VEPCO NOMAD CODE AND MODEL SUPPLEMENTAL INFORMATION.

Docket # 50-280
Control # 8407170305
Date 7/6/84 of Document:
REGULATORY DOCKET FILE

RESPONSE TO QUESTIONS AND COMMENTS ON VEPCO NOMAD CODE AND MODEL (VEP-NFE-1)

FIGURE 5.7

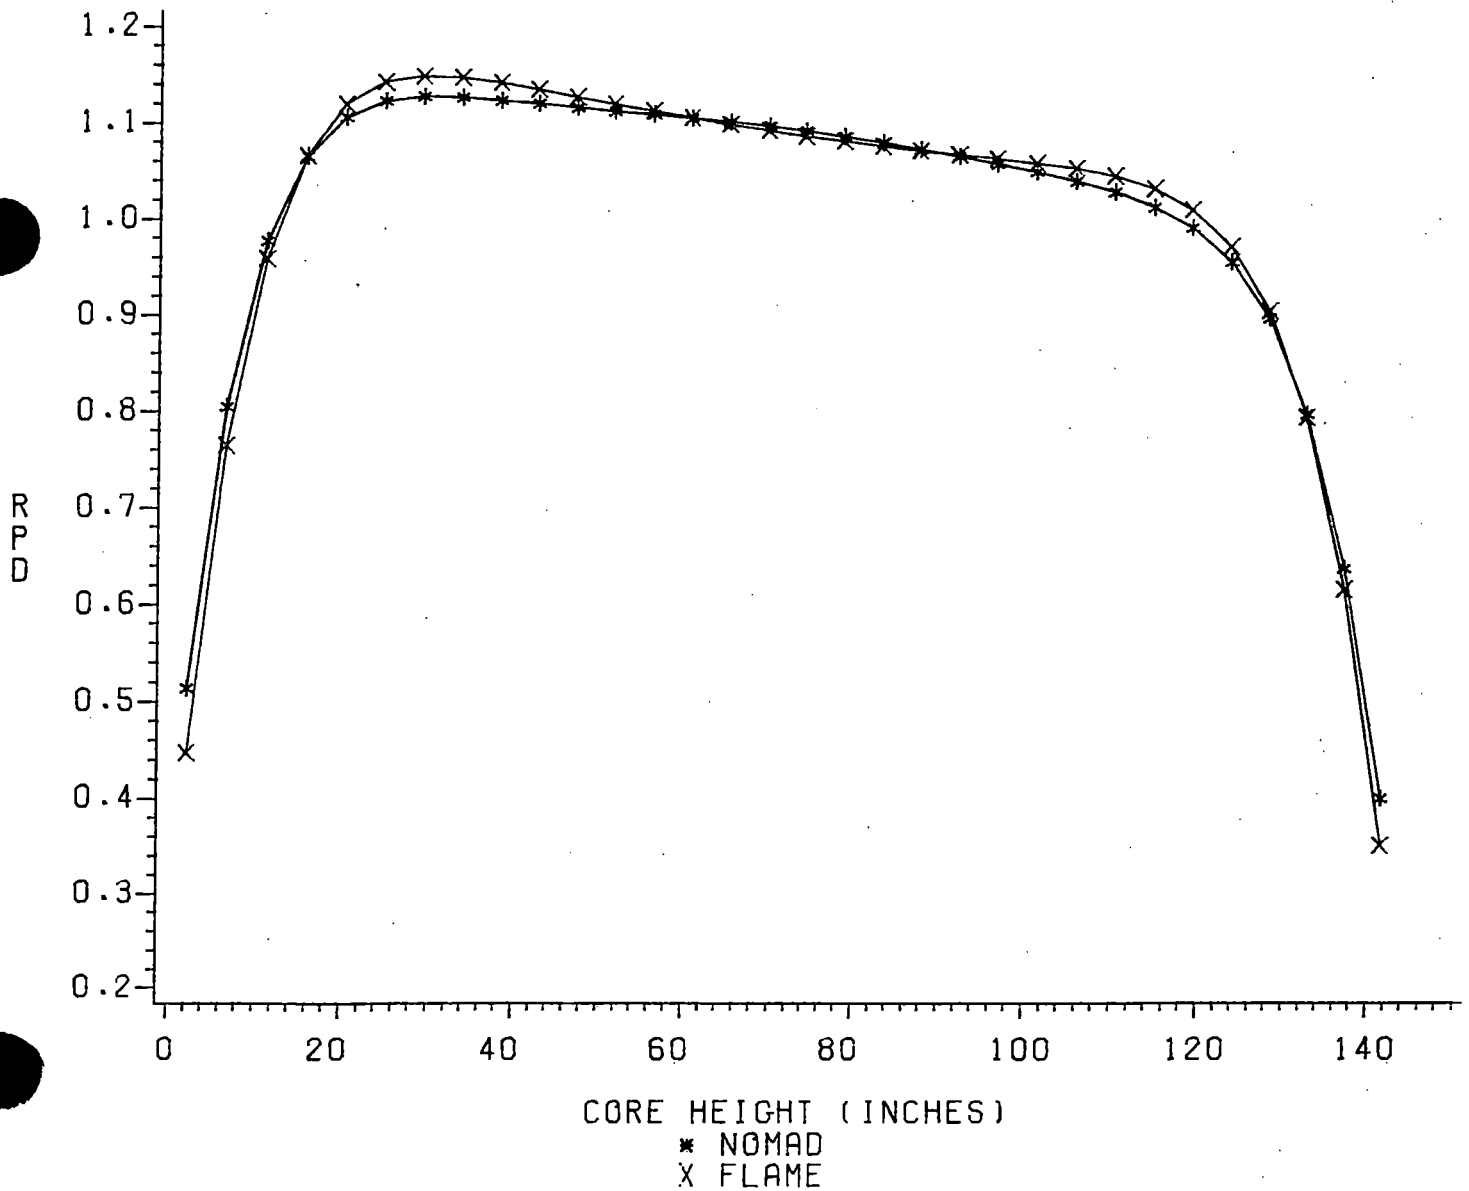
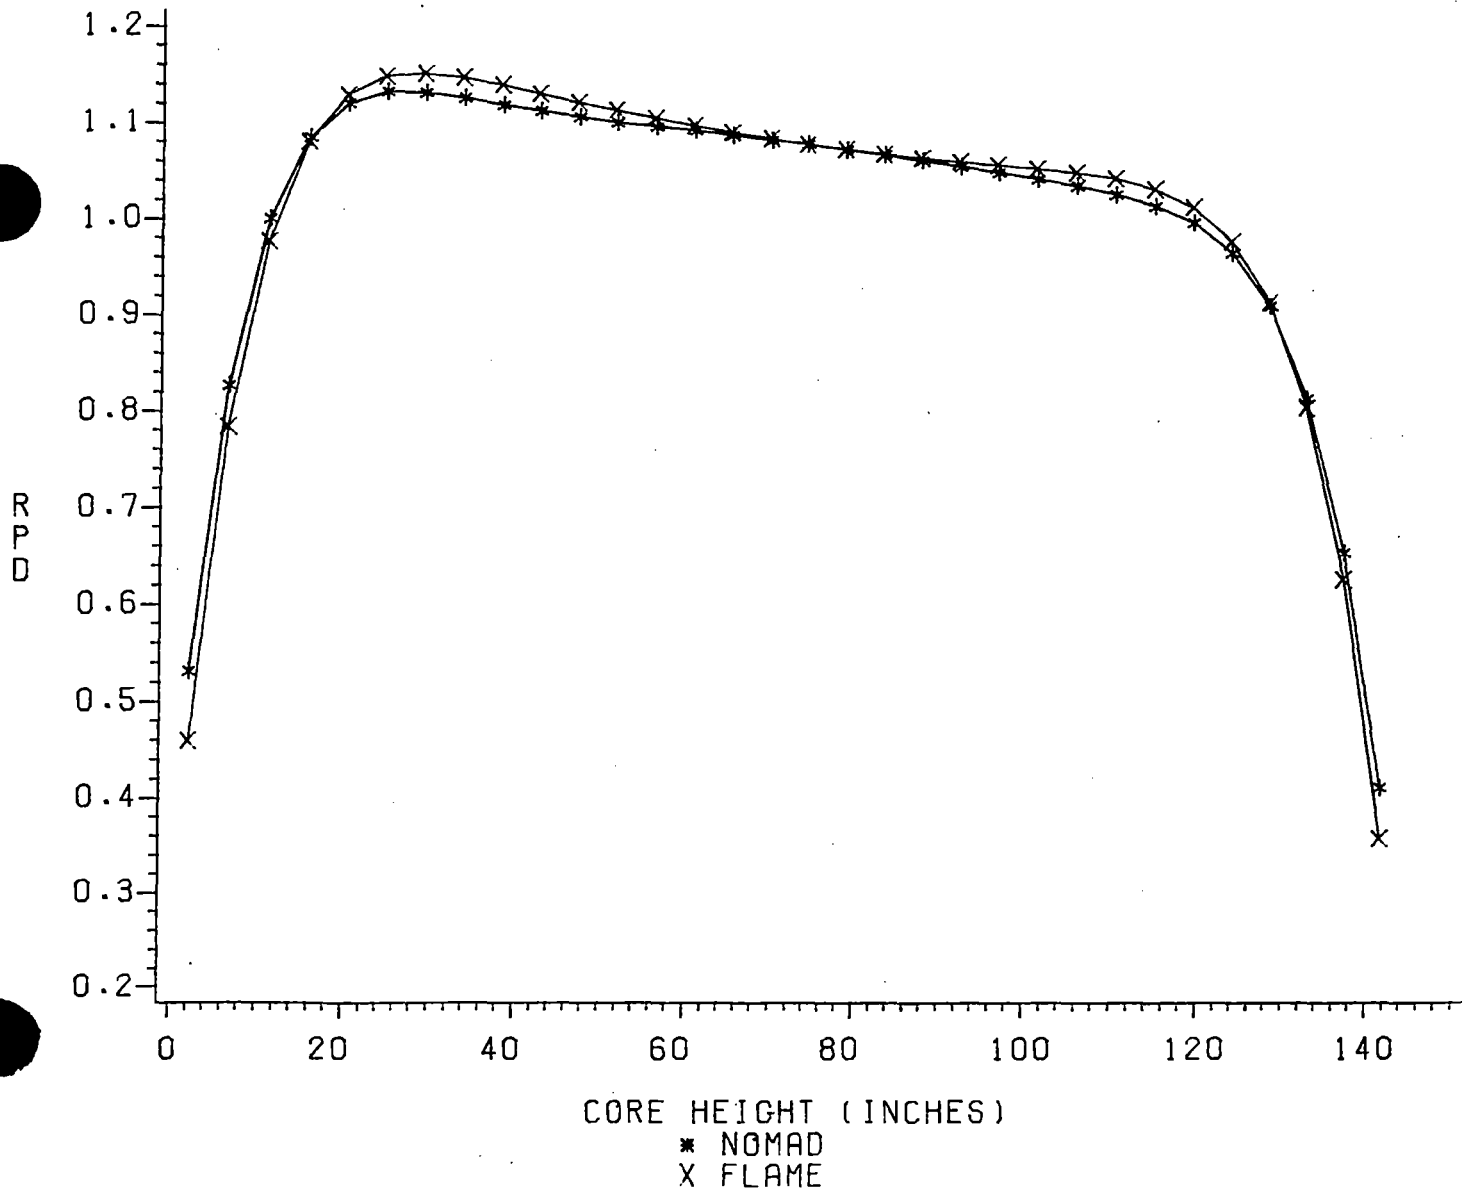
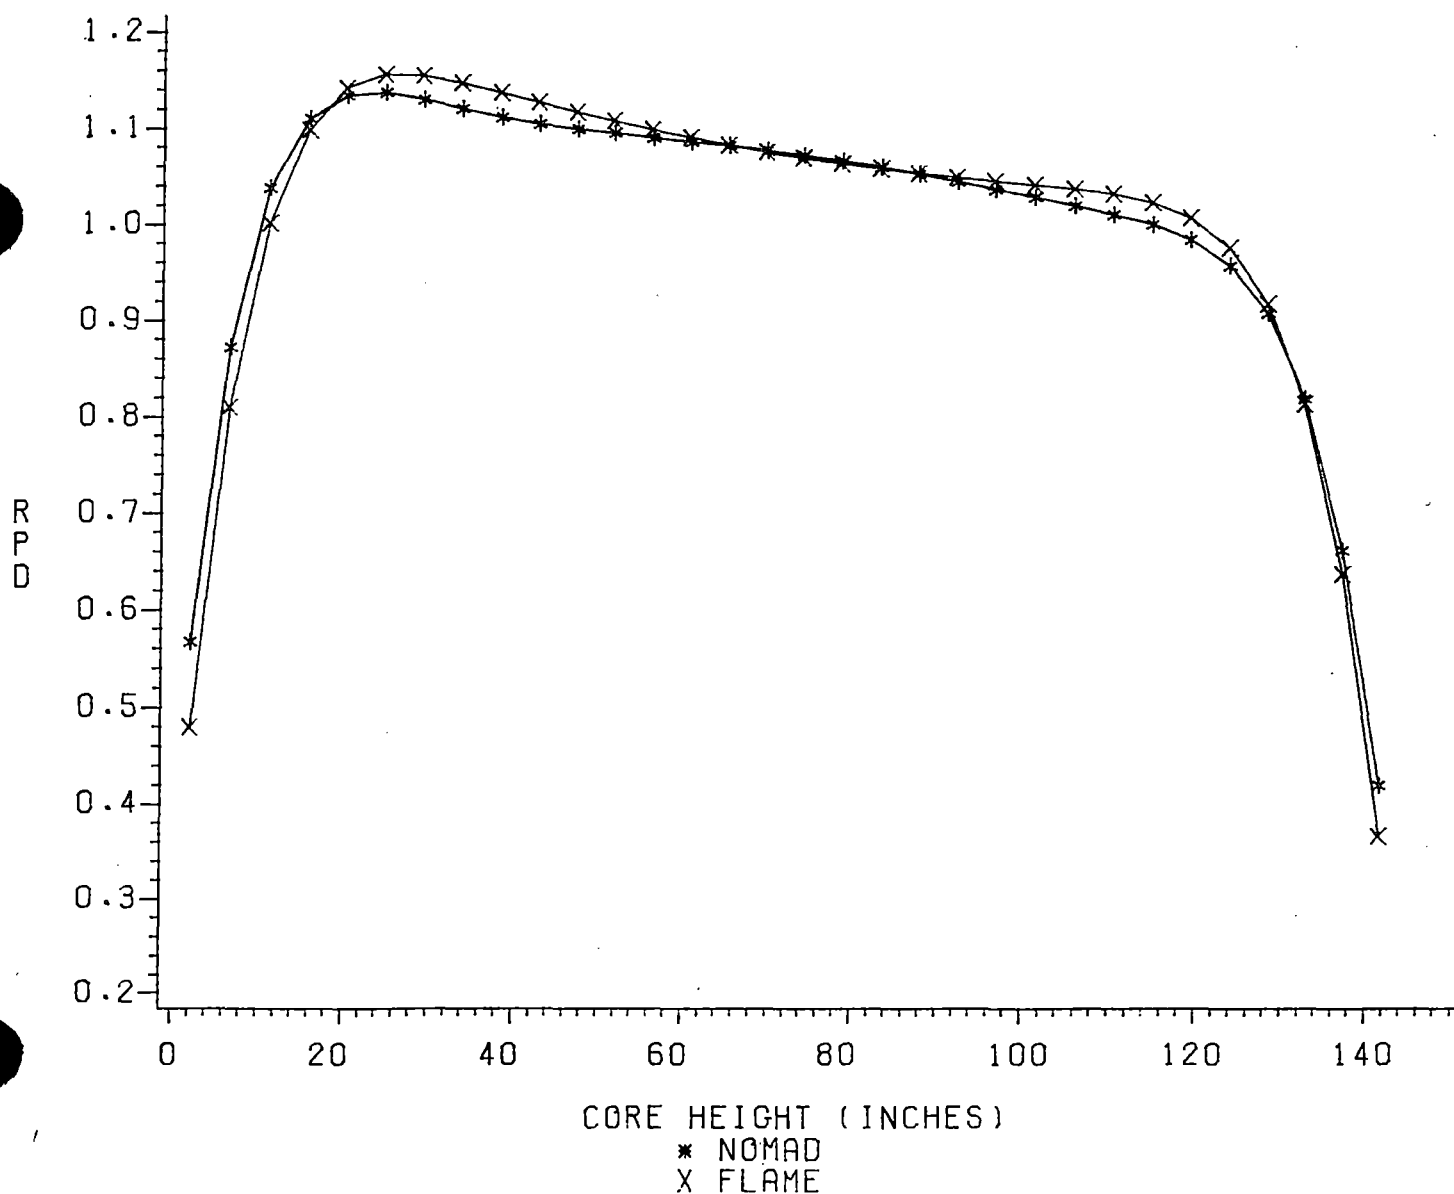
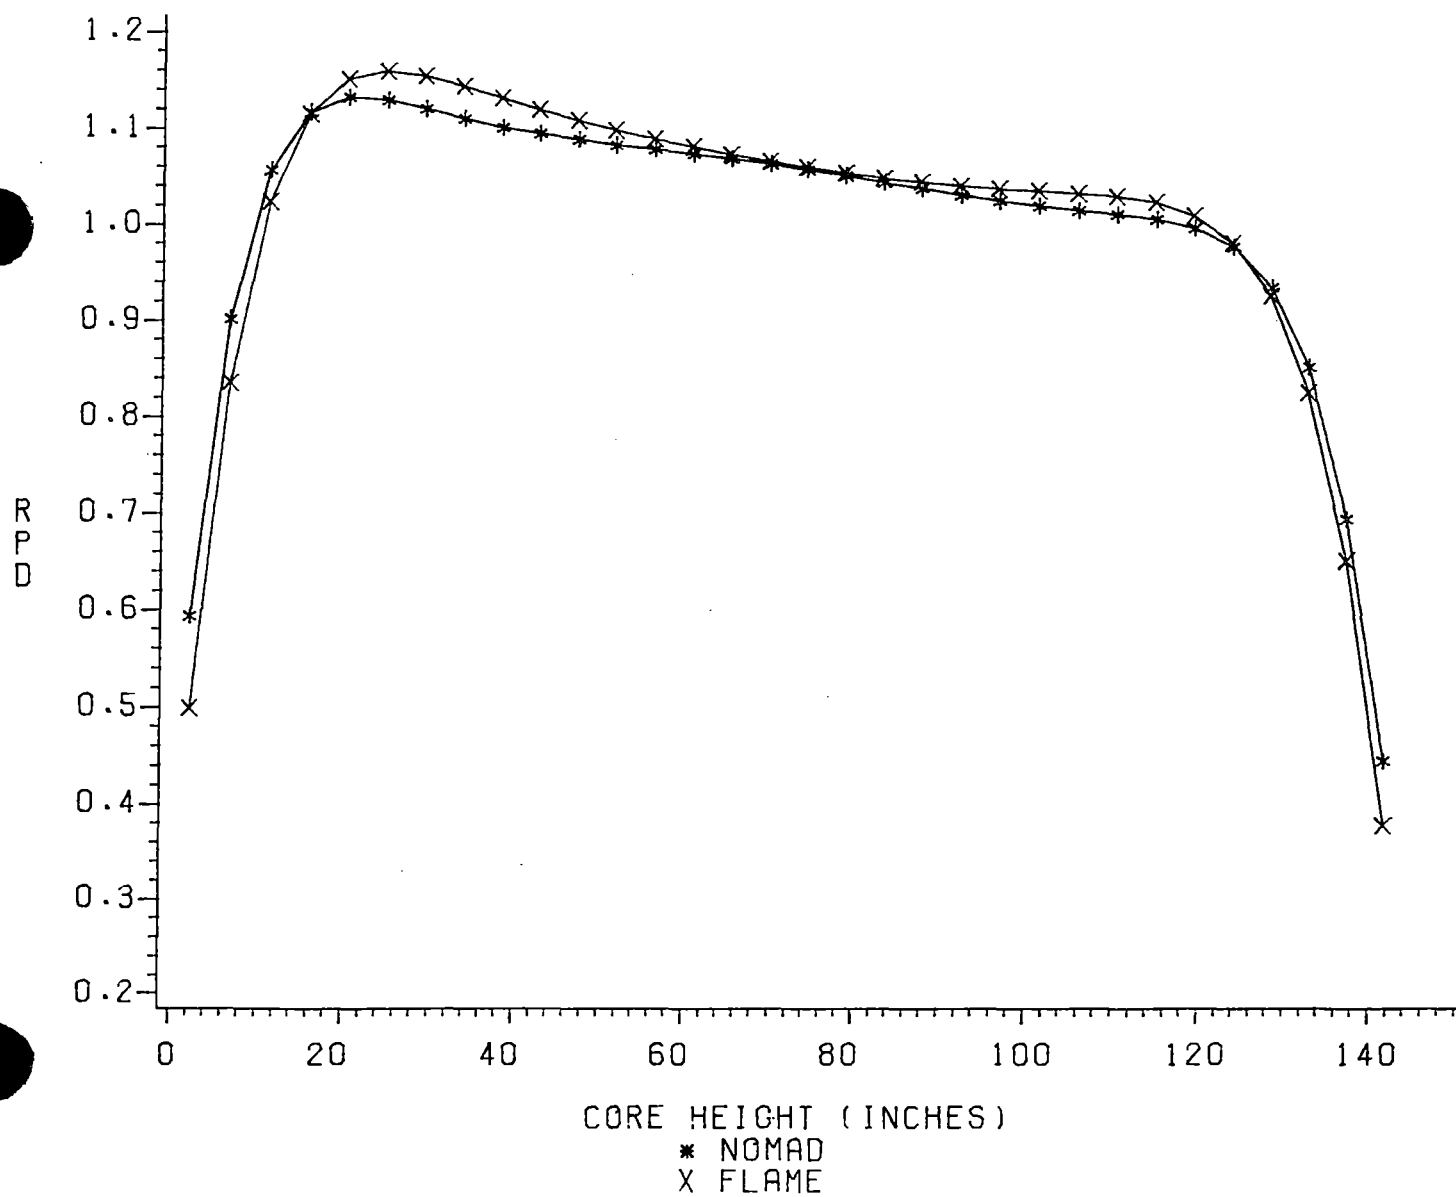
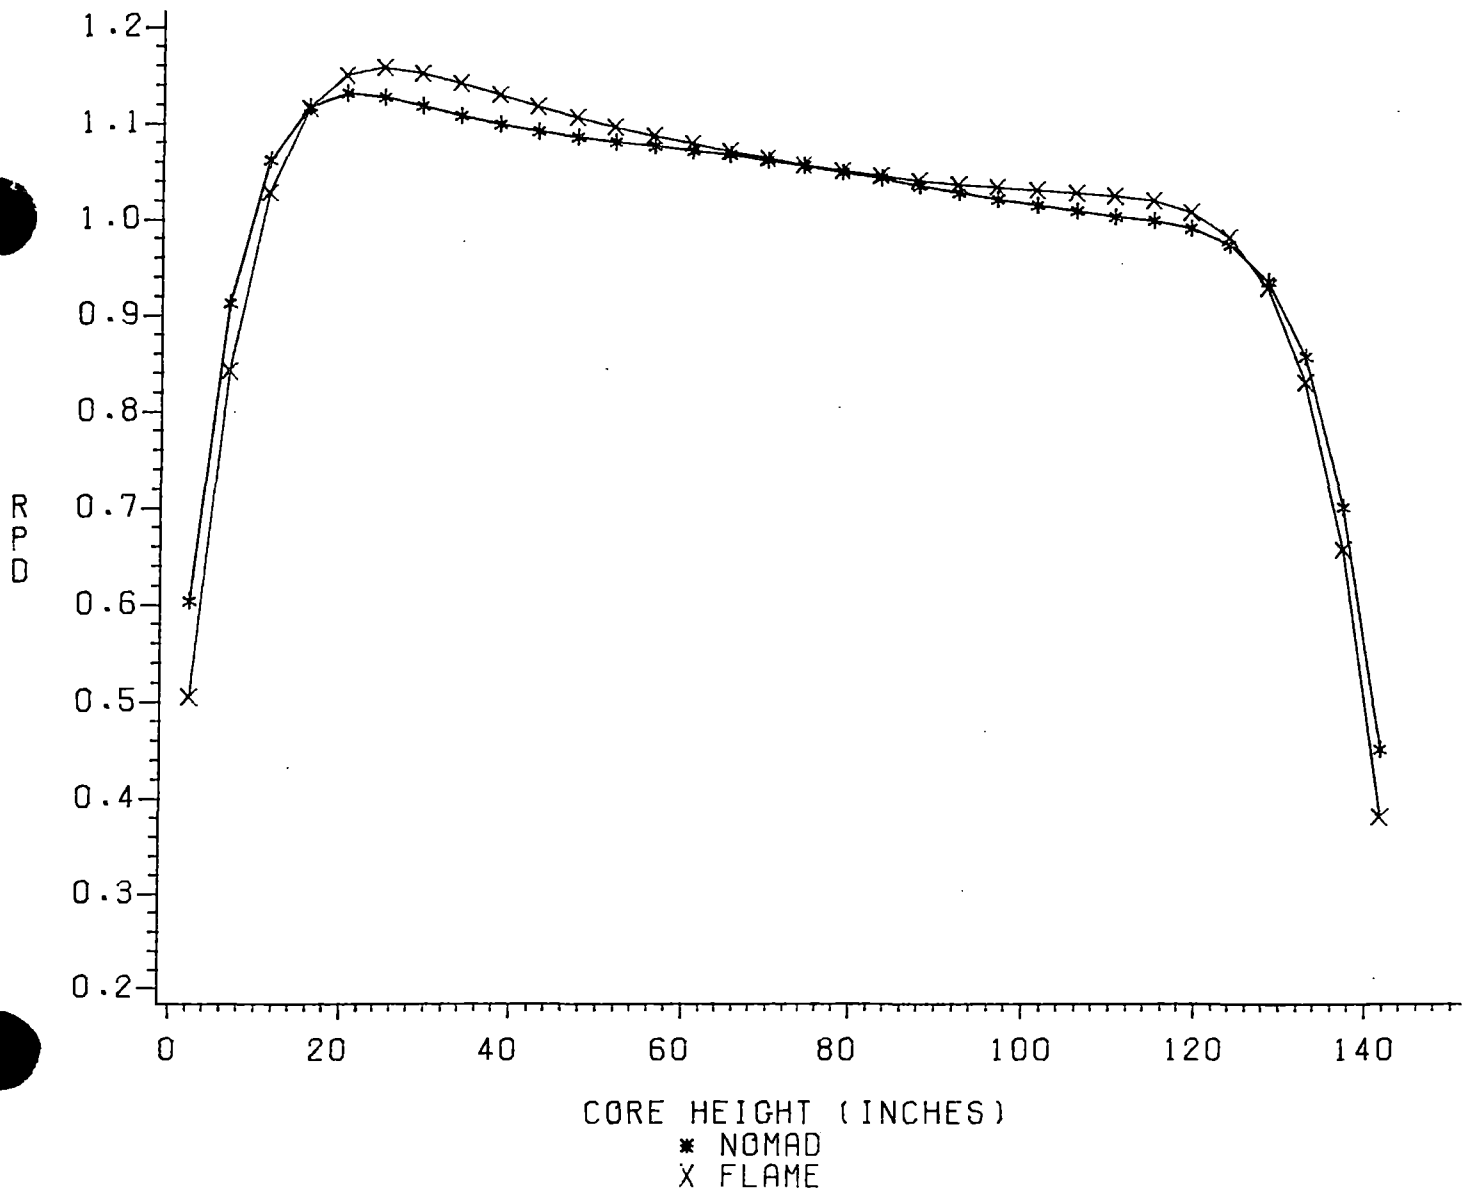
Question 5. The normalization of NOMAD to FLAME solely on the basis of flux difference and mid-plane power in the buckling search seems too limited. In addition, performing the buckling search for rodded configurations with the xenon distribution "frozen at HFP, ARO equilibrium conditions..." does not sound like the right way to do this.

VEPCO's experience has been that axial offset, midplane power and critical boron are sufficient conditions for normalizing NOMAD to FLAME. This is very similar to the 1-D to 3-D normalization methods used by some vendors. Comparisons of NOMAD and FLAME axial power distributions for every burnup step of S1C7 are presented in Figures 5.1 through 5.11. The maximum difference between NOMAD and FLAME is 2.9% for these cases.
